ADDENDUM NO. 1

**Renovation to Exterior of Jefferson Barracks Building 27
Jefferson Barracks
St. Louis, Missouri
PROJECT NO.: T2335-01**

A-201

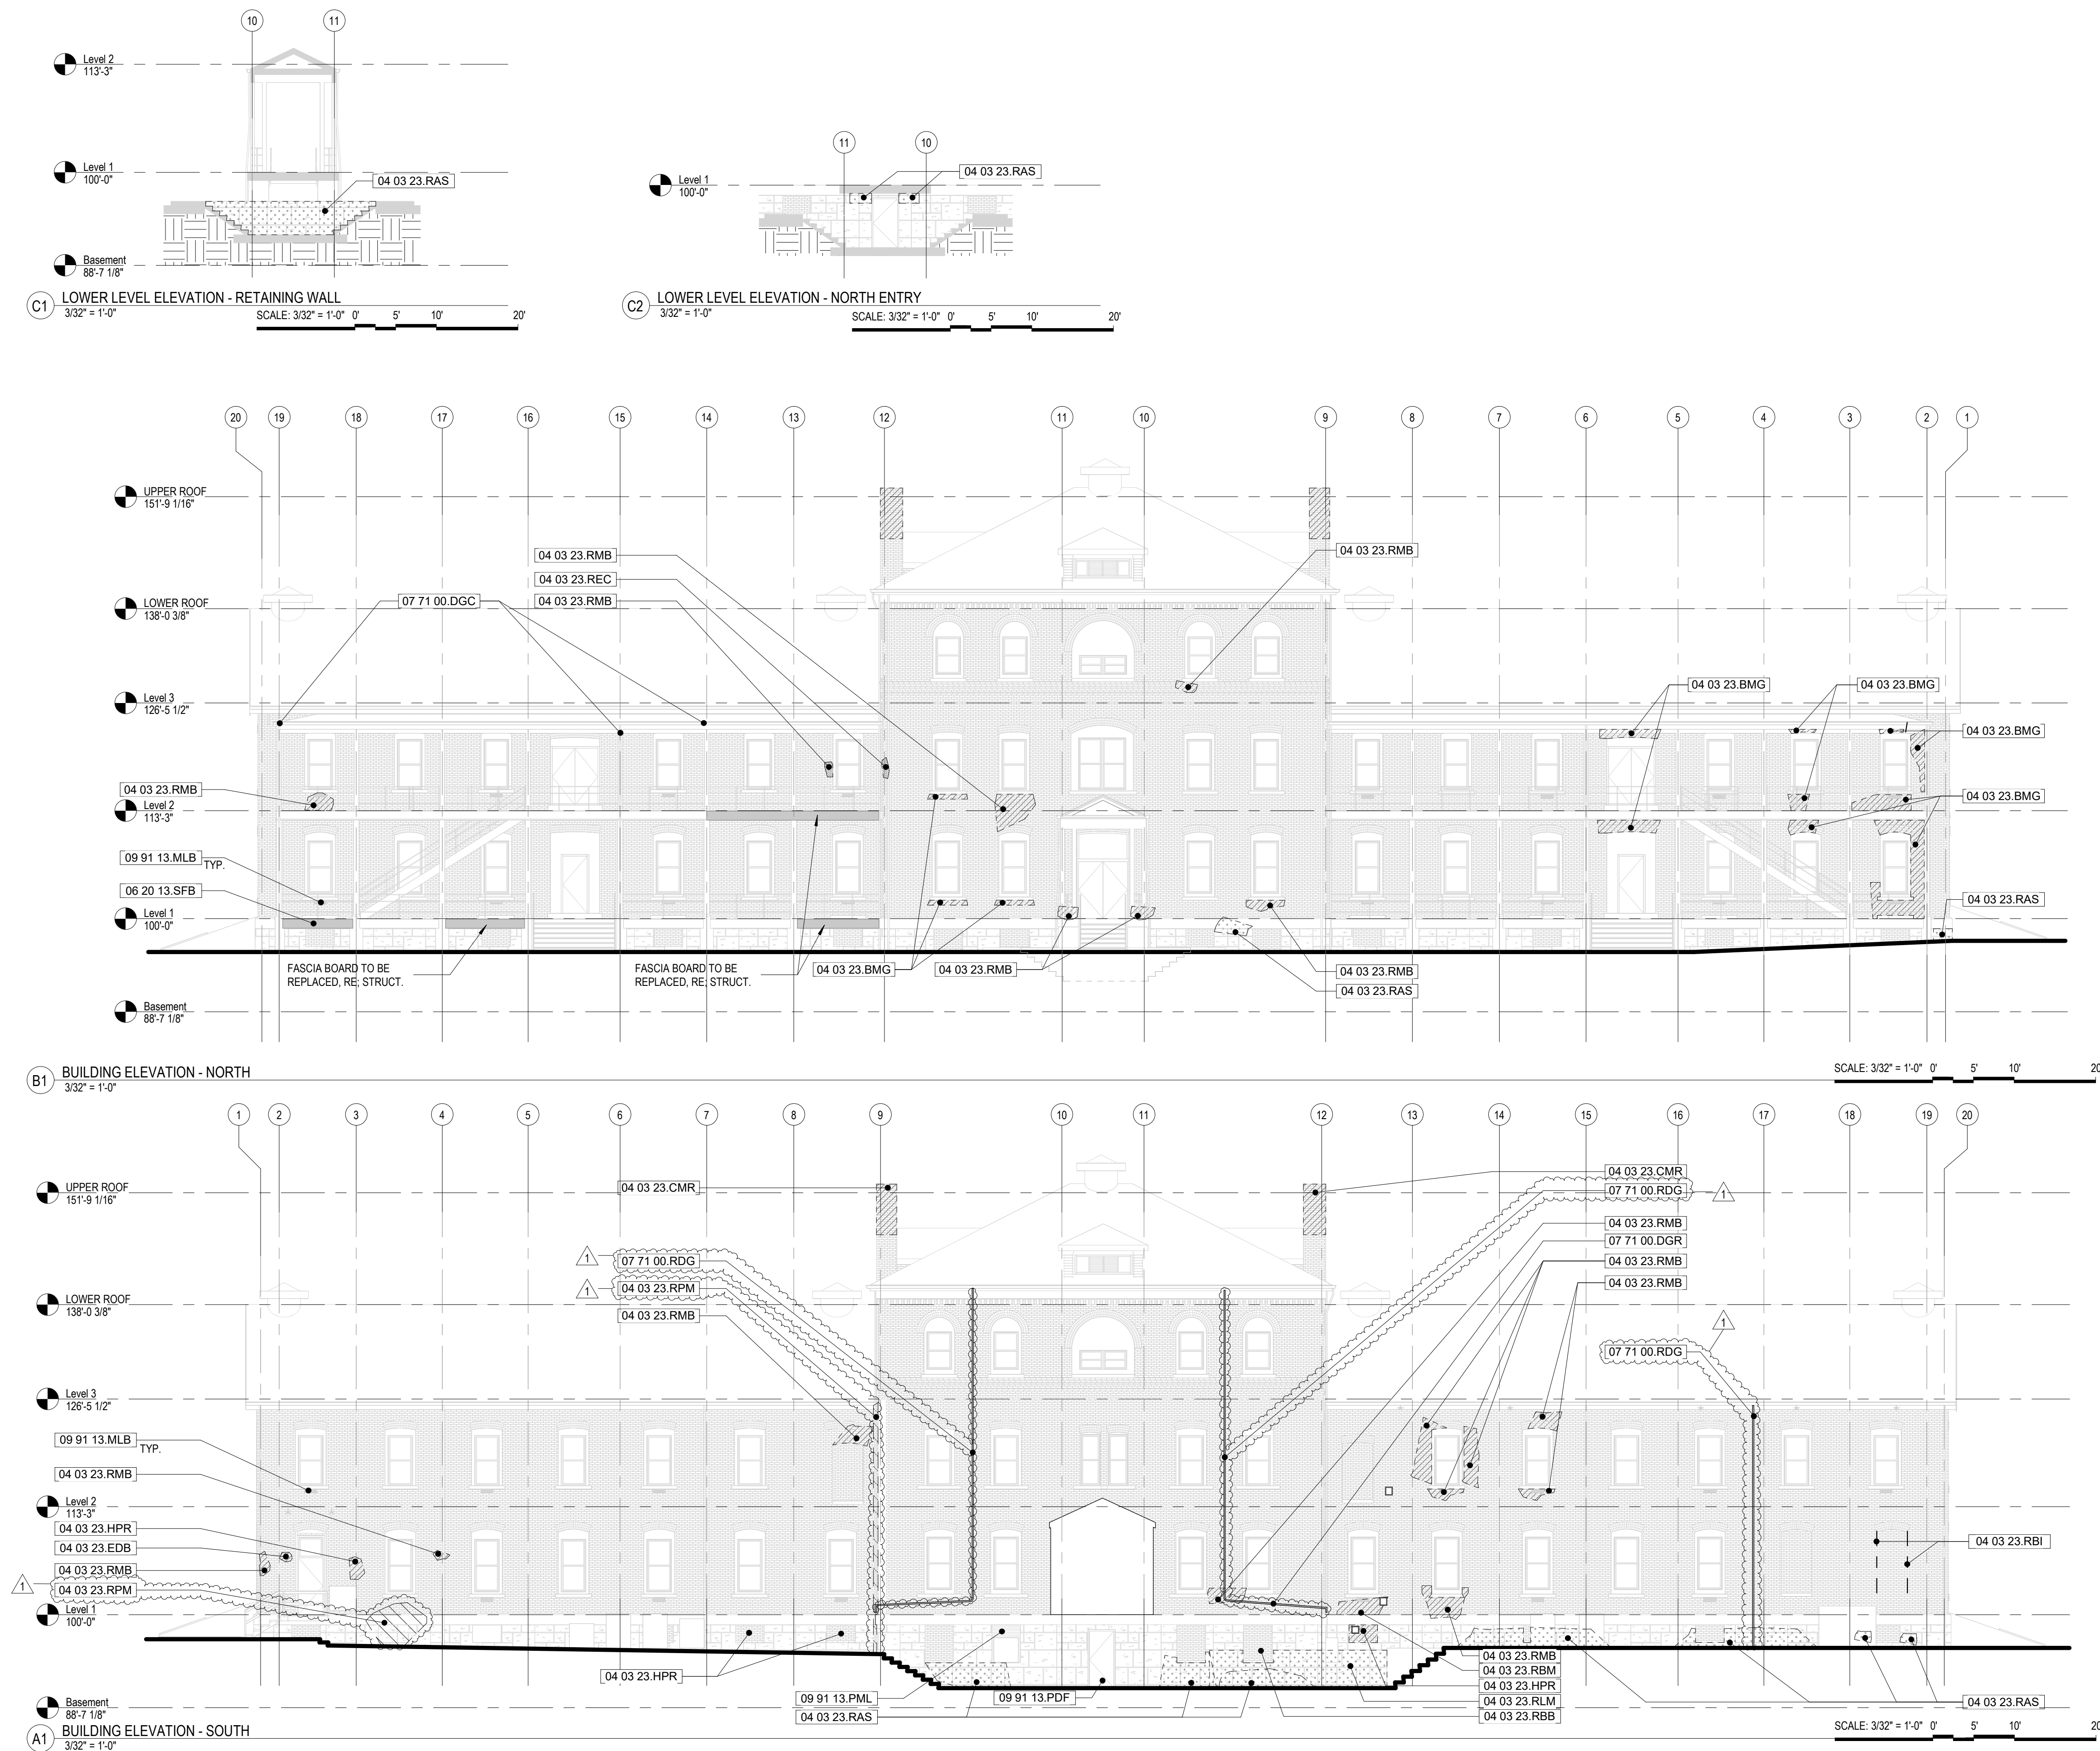
1. A-201 North, South, and Retaining Wall Elevations
 - a. ADDED scope of plant removal.
 - b. REVISED existing downspouts to be replaced.
 - c. ADDED note to general notes to reseal seam on aluminum gutters
2. A-202 East and West Building Elevations
 - a. REVISED existing downspouts to be replaced.
 - b. ADDED note to general notes to reseal seam on aluminum gutters

- RESEAL ALL SEAMS BETWEEN GUTTER SECTIONS
- ALL EXISTING BRICK, GRANITE WATER COURSE STONE, AND LIMESTONE ASHLAR BASE TO BE CLEANED. EXISTING METAL ELEMENTS EMBEDDED AND ATTACHED TO BRICK TO BE CLEANED. GENERAL MASONRY CLEANING TO BE INCLUDED AS ALTERNATE 01 - SEE SPECIFICATION SECTION 01 2300.
